Deviation From Design

DfD : DfD-0002

**Taran Laval – SAAA Builder 7417
Van's Aircraft RV7 - 73918**

Horizontal Stabiliser Front Spar – Elongated Holes

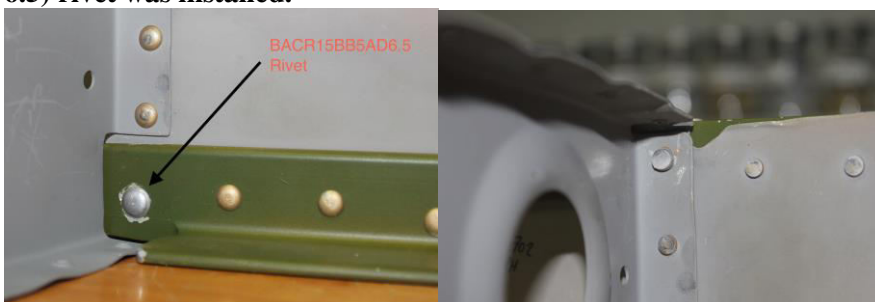
During the riveting of HS405 & HS404 ribs to the Fwd Spar of the Horizontal Stabiliser one hole in which rivets had been removed from that attaches the HS405-HS702-HS714 became elongated.

Van's Technical Support were contacted and advised to move up to the next rivet size and that I had to determine my own length.

The hole was drilled out to a 5/32" size and a BACR15BB5AD6.5 (Interchangeable with AN470AD5-6.5) rivet was installed.
